THE VILLAS AT CLAREMONT RANCH

TRACT A & G CLAREMONT RANCH FILING NO 7

PUD DEVELOPMENT PLAN & PRELIMINARY PLAN

PUD V_1 redlines.pdf Markup Summary 2-19-2021

Potentially Seasonal Shallow Groundwater Area

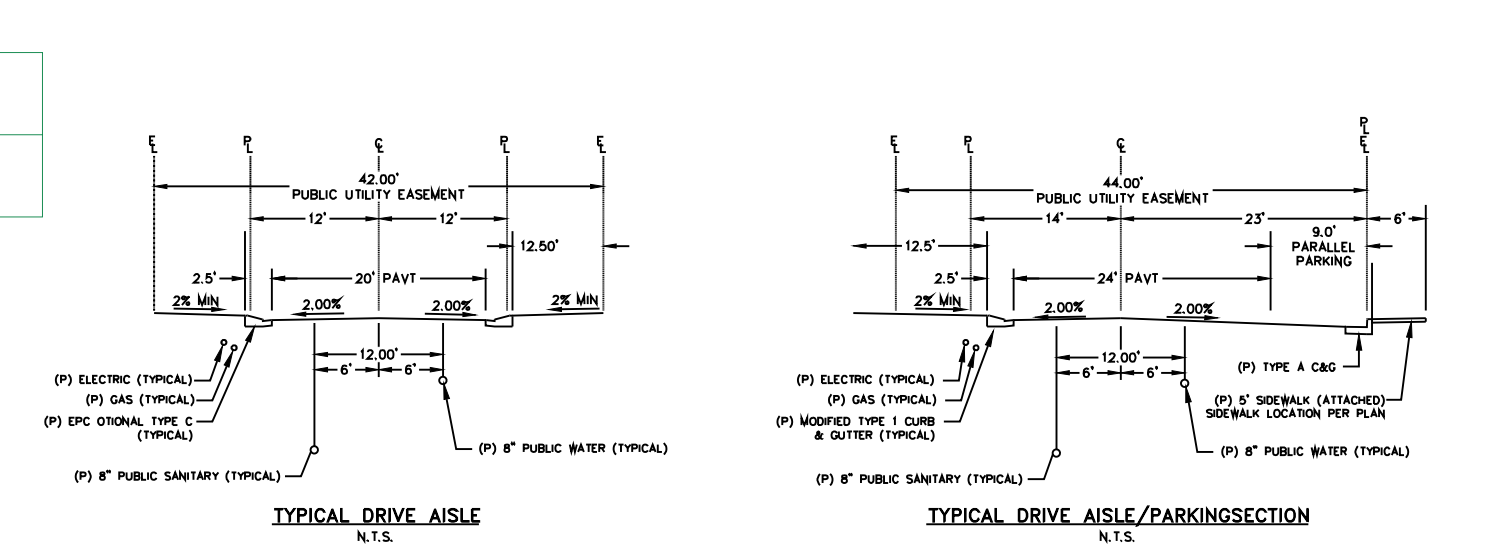
Please identify the lots that will require the groundwater mitigation...Please identify if the HOA will be responsible for the perimeter drain maintenance.

Tracts & Adjacent Property Owners Exhibit

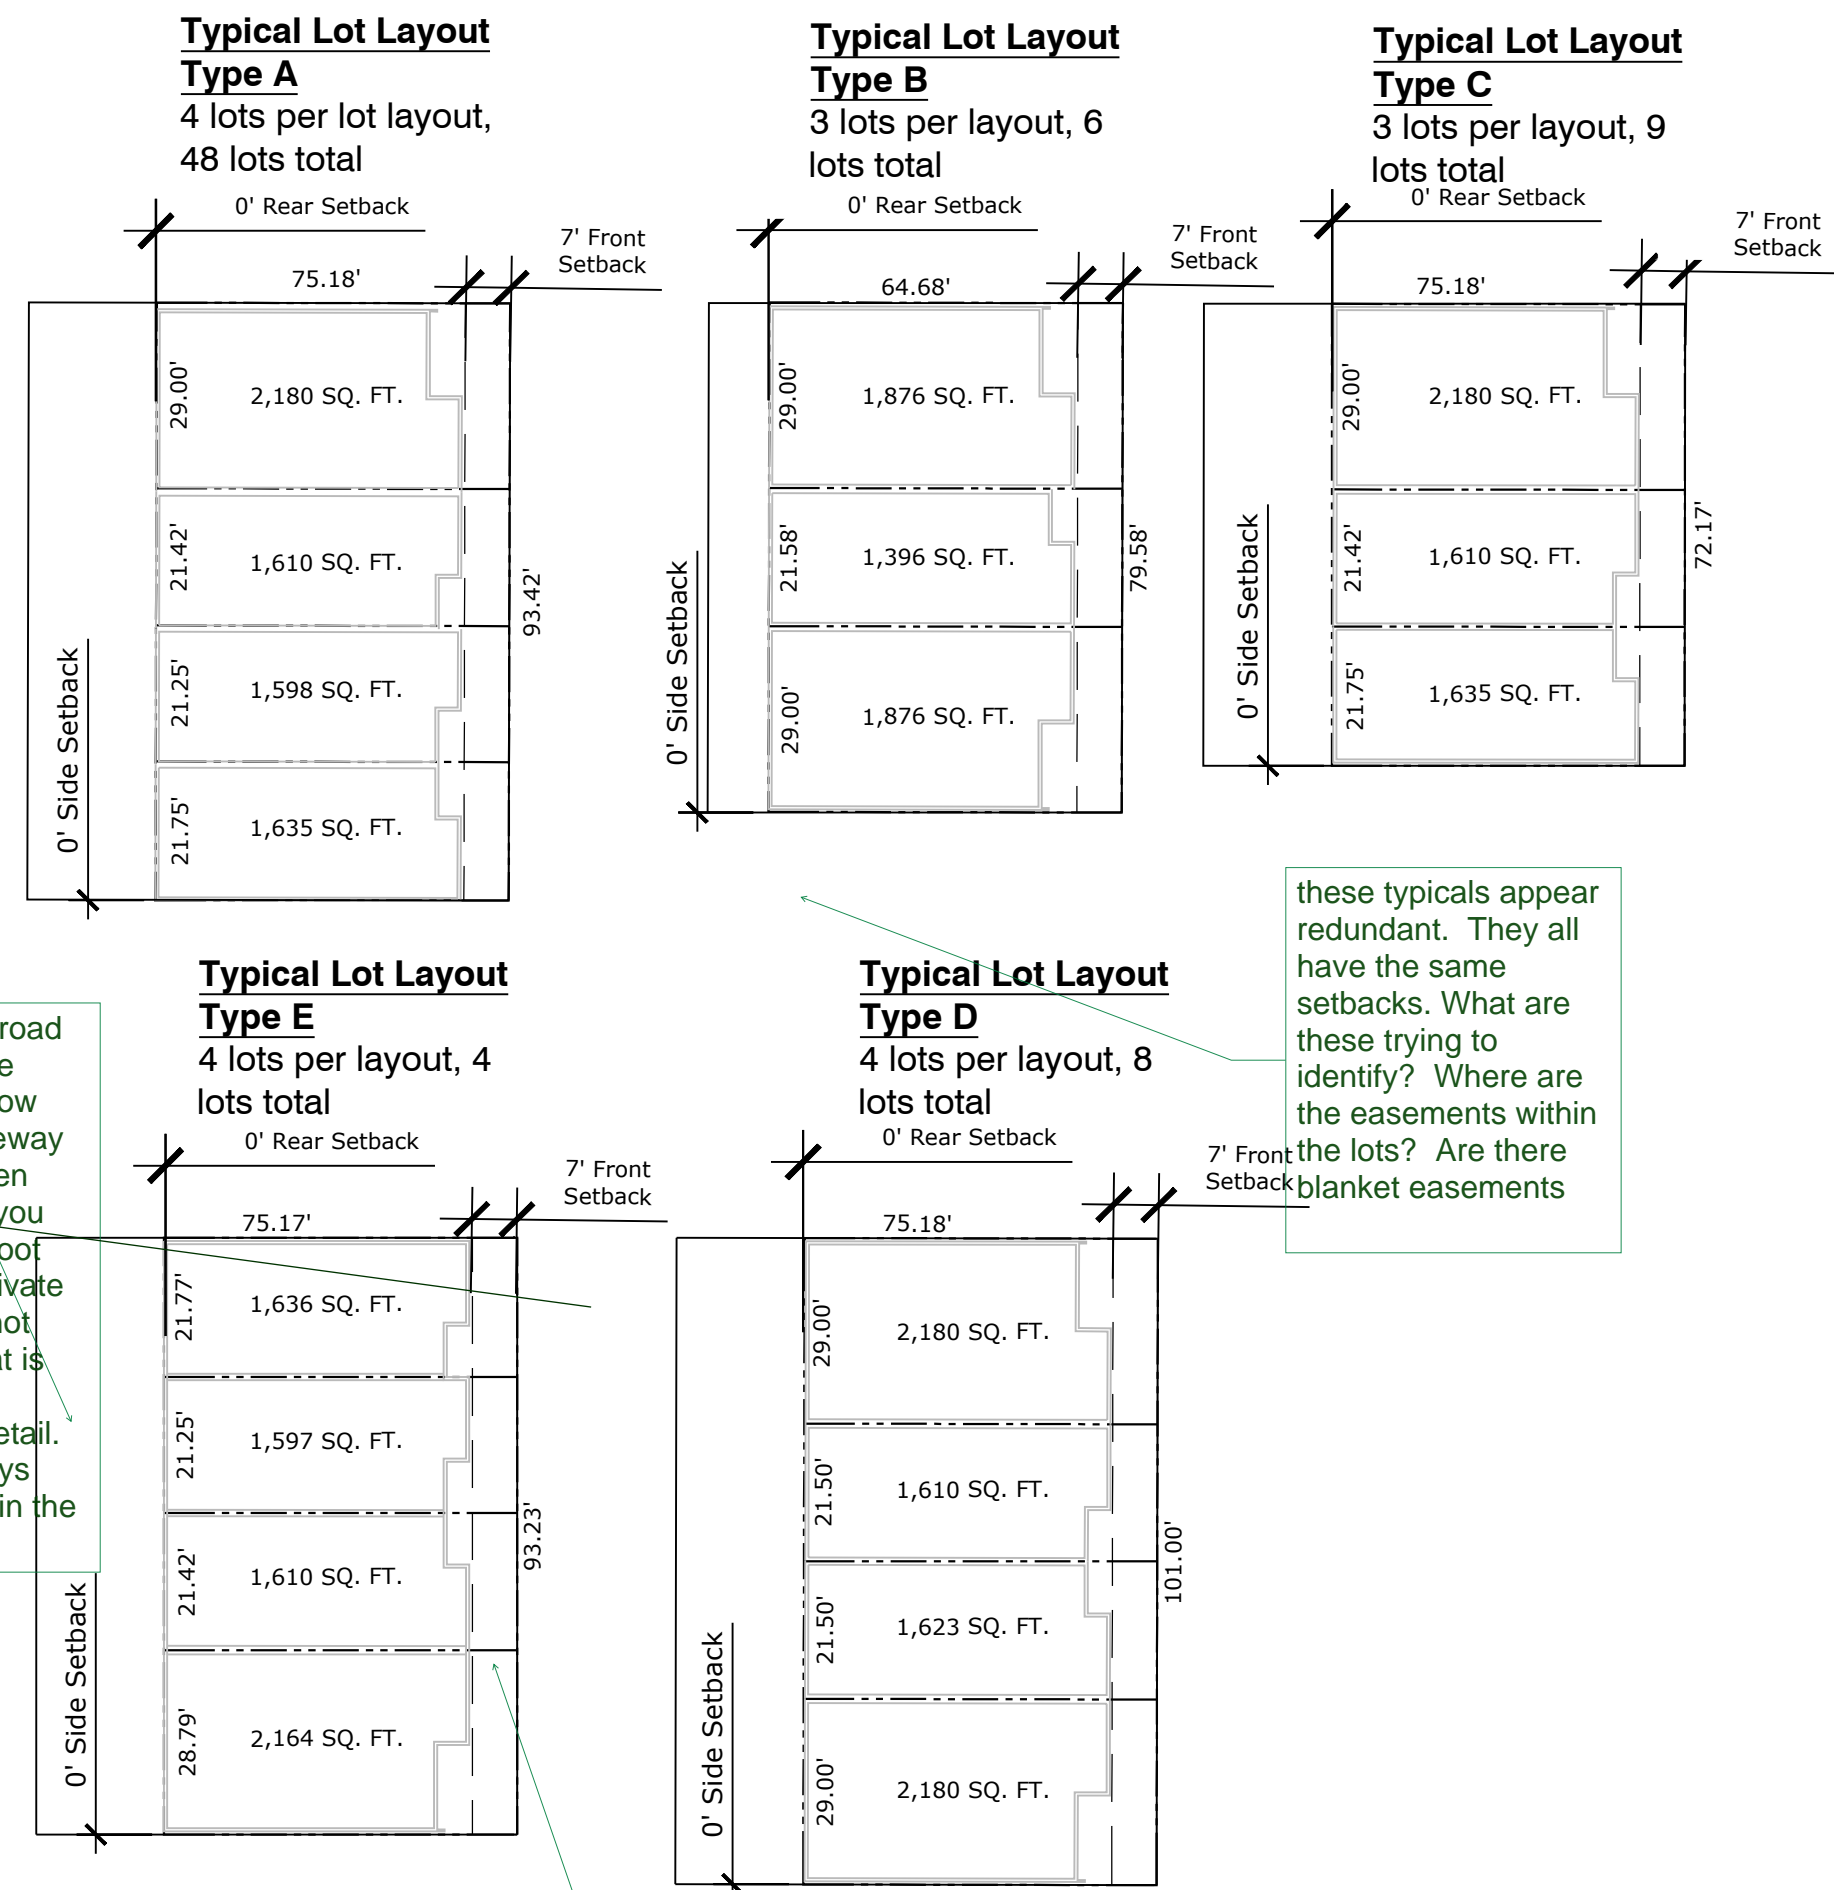
KEY for line (and hatch if used) symbols; Each pages line symbol should be consistent through out plan set

label these lines and dimension from property line...

repeat label if this is tract E

Label sidewalk

Property line boundary w/ dimensions please add

why is the open space hatch outside of the property boundary? Is that area included in tract E sf? It should not include are outside of the property boundary or road dedication.

is this box representing something?

is something missing? is this a sidewalk line?

identify the on-street parking and clearly label where no parking is permitted... Show sign details.

perhaps use a different hatch to ensure clarity on sidewalks throughout plan set.

if there is parking its NOT openspace

Preliminary Plan

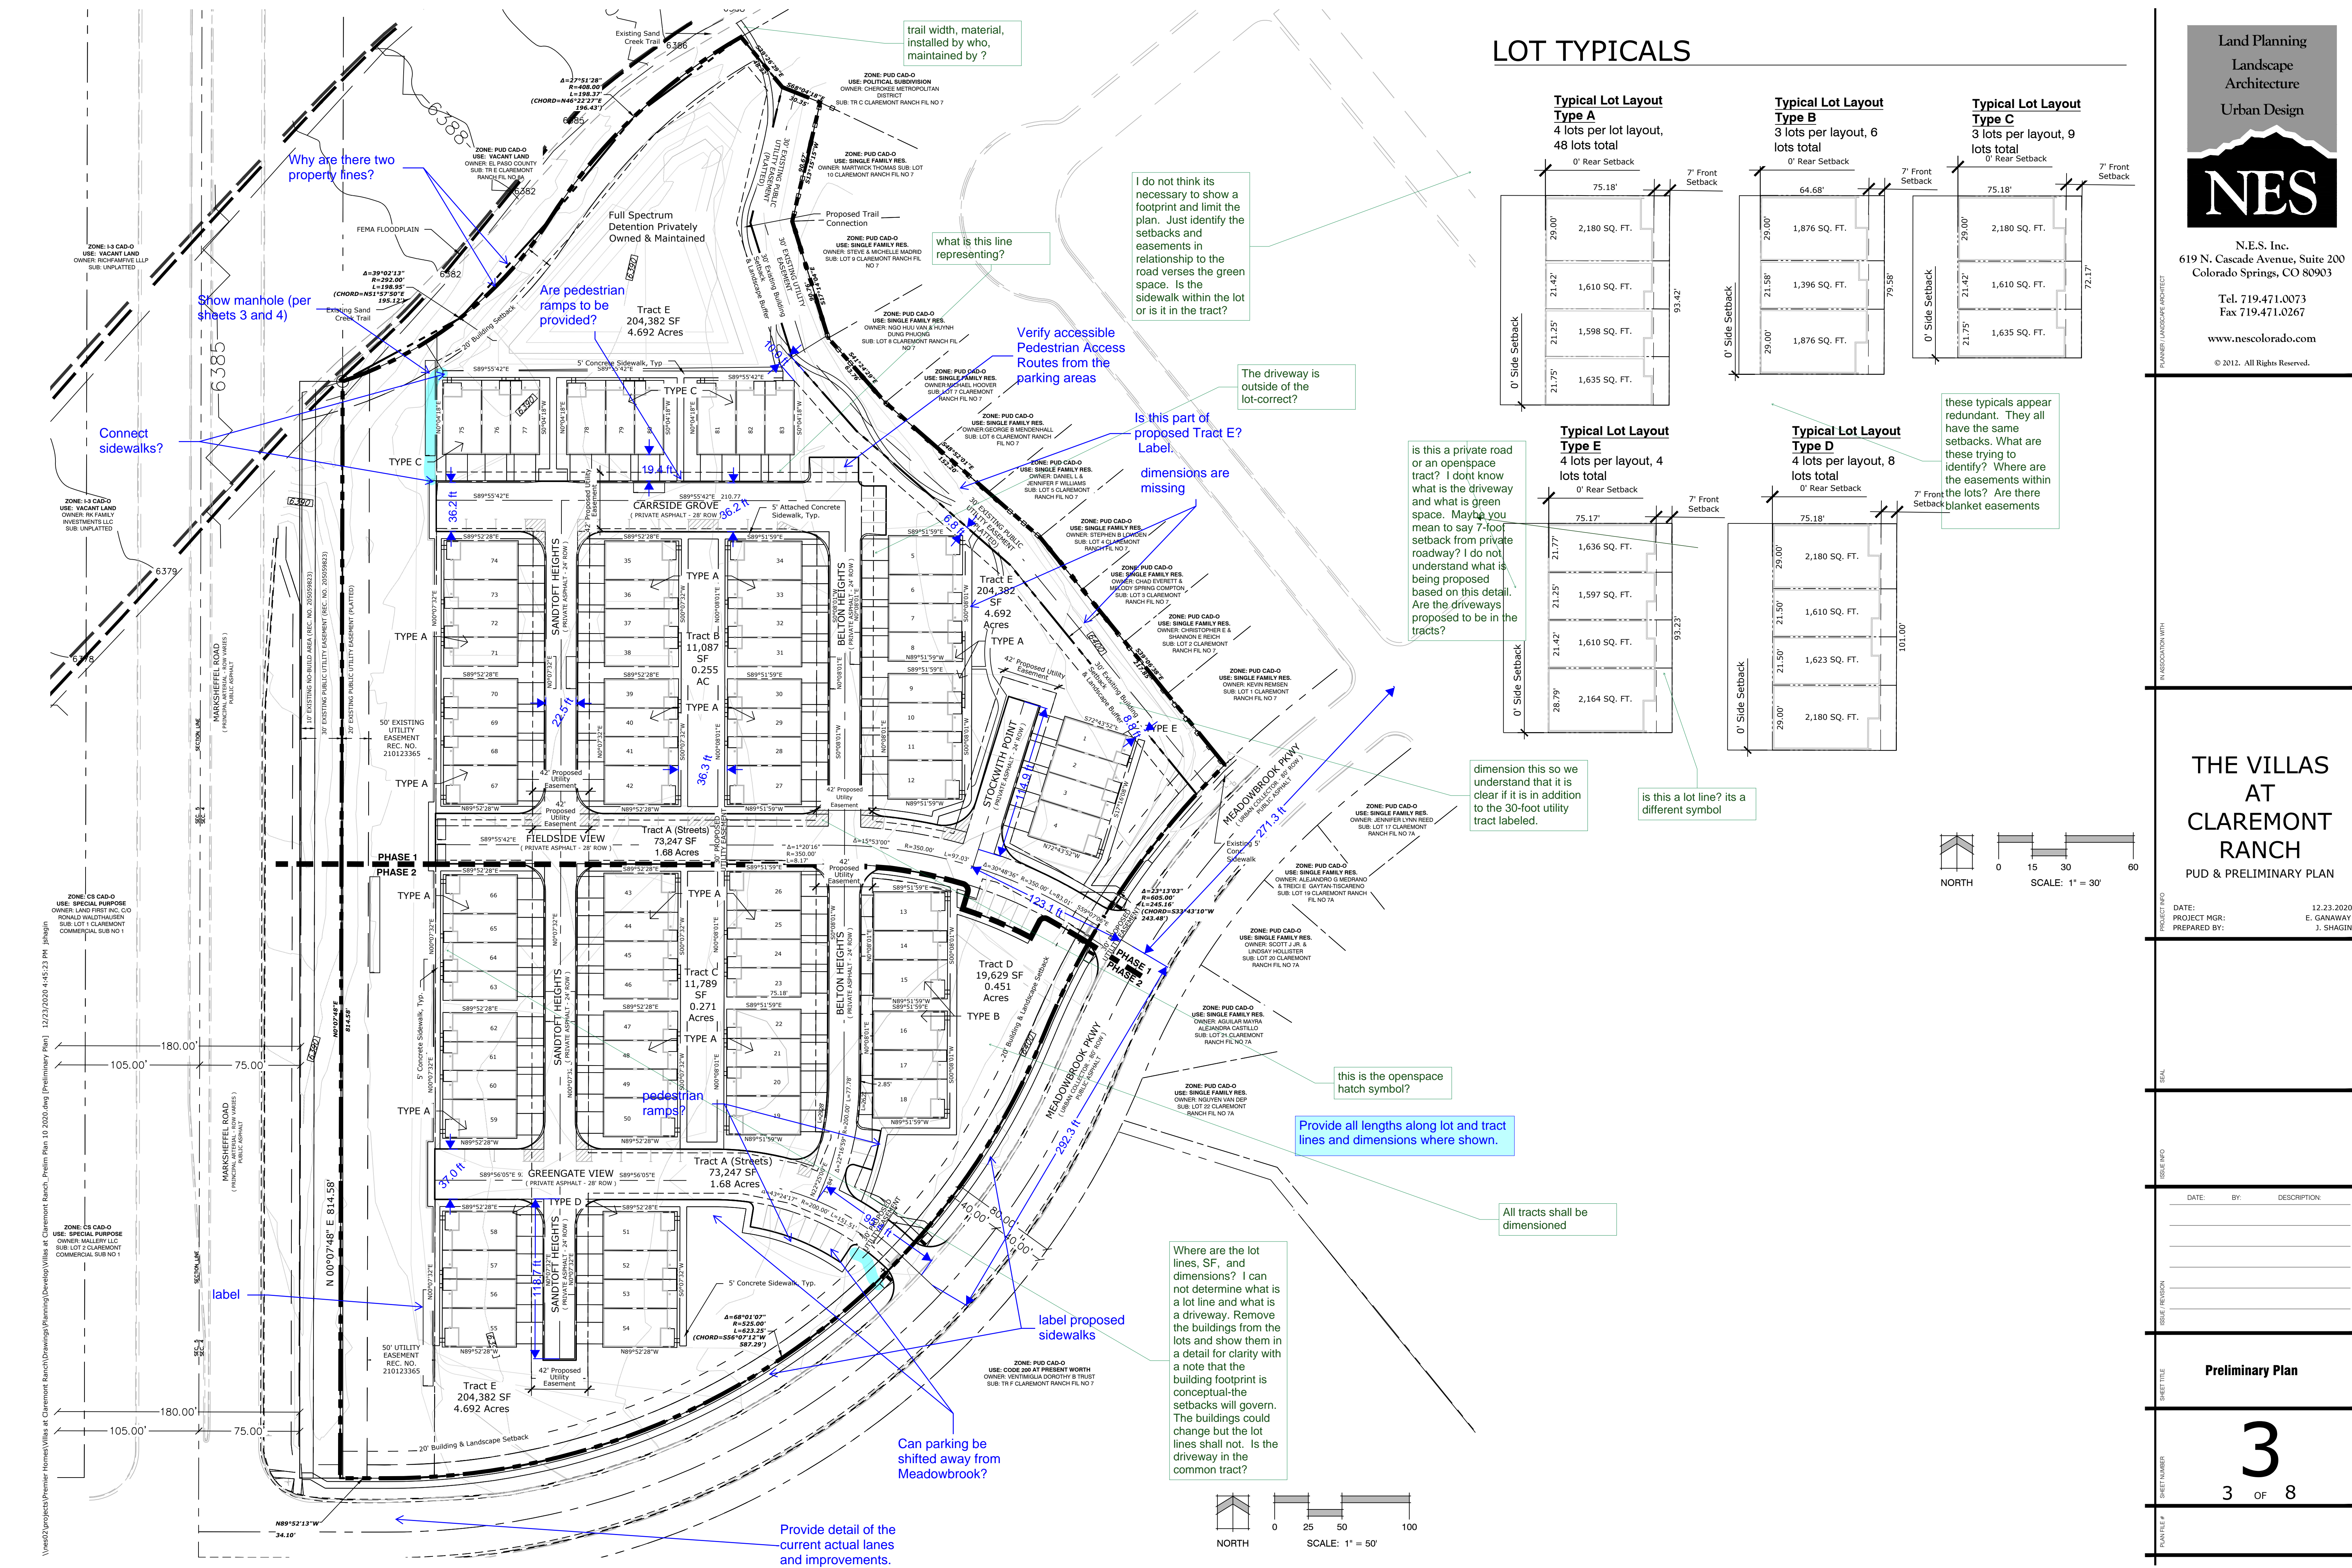
LOT TYPICALS

these typicals appear redundant. They all have the same setbacks. What are these trying to identify? Where are the easements within the lots? Are there blanket easements

is this a private road or an openspace tract? I dont know what is the driveway and what is green space. Maybe you mean to say 7-foot setback from private roadway? I do not understand what is being proposed based on this detail. Are the driveways proposed to be in the tracts?

dimension this so we understand that it is clear if it is in addition to the 30-foot utility tract labeled.

is this a lot line? its a different symbol

this is the openspace hatch symbol?

Provide all lengths along lot and tract lines and dimensions where shown.

All tracts shall be dimensioned

Where are the lot lines, SF, and dimensions? I can not determine what is a lot line and what is a driveway. Remove the buildings from the lots and show them in a detail for clarity with a note that the building footprint is conceptual-the setbacks will govern. The buildings could change but the lot lines shall not. Is the driveway in the common tract?

I do not think its necessary to show a footprint and limit the plan. Just identify the setbacks and easements in relationship to the road verses the green space. Is the sidewalk within the lot or is it in the tract?

Verify accessible Pedestrian Access Routes from the parking areas

what is this line representing?

Why are there two property lines?

Are pedestrian ramps to be provided?

Show manhole (per sheets 3 and 4)

Connect sidewalks?

label

Can parking be shifted away from Meadowbrook?

Provide detail of the current actual lanes and improvements.
